D. Ashley - FW: Audit Q & A (Question Numbers AMP-141, 210, 356)

NRC Information Request Form

Item No
AMP-210

Item No
AMP-356

Sandbed Bay 9 Location D

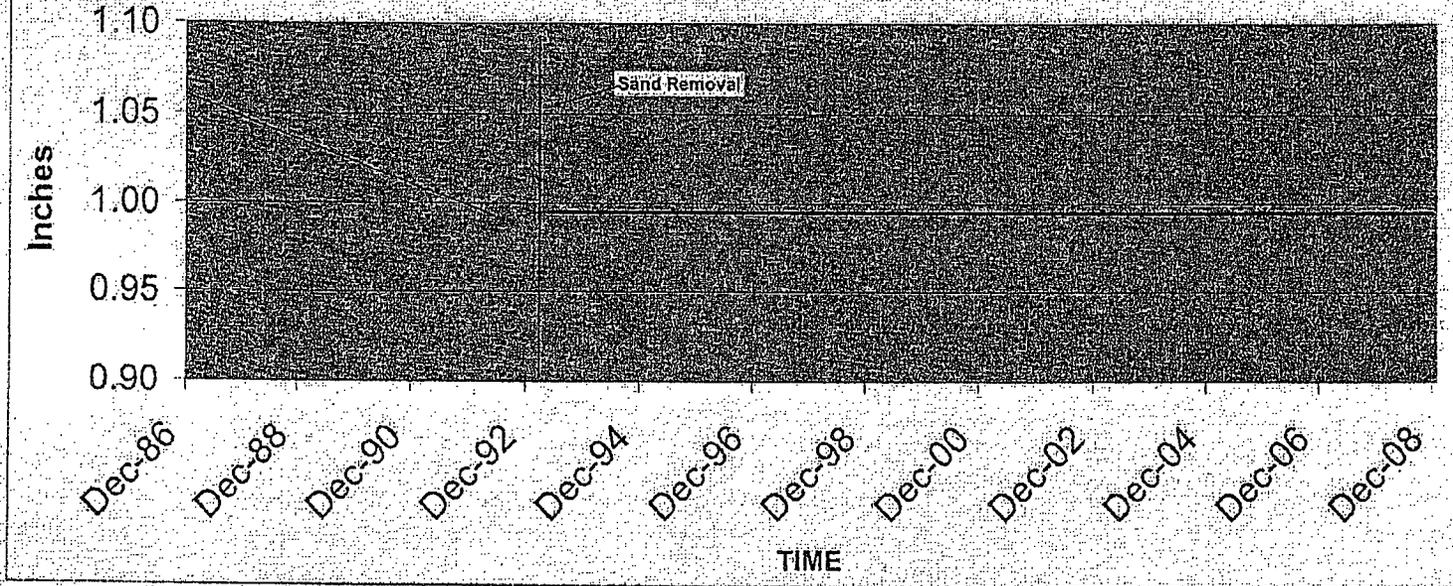
(3) For each grid location, submit a graph of remaining thickness versus time, using the UT readings since the initiation of the program (both prior to and following removal of the sand and application of the external coating).

3. A graph representing the remaining thickness versus time using UT reading since the initiation of the program (both prior to and following removal of the sand and application of the external coating) for location 9D, 11A, 11C, 13A, 13D, 15D, 17A, 17D, 17/19, 19A, 19B, and 19C is included in the attached graph. Other locations (i.e. 1D, 3D, 5D, 7D, 9A, 13C, and 15A) are not included because wall thinning is not significant and the trend line will be essentially a straight line.
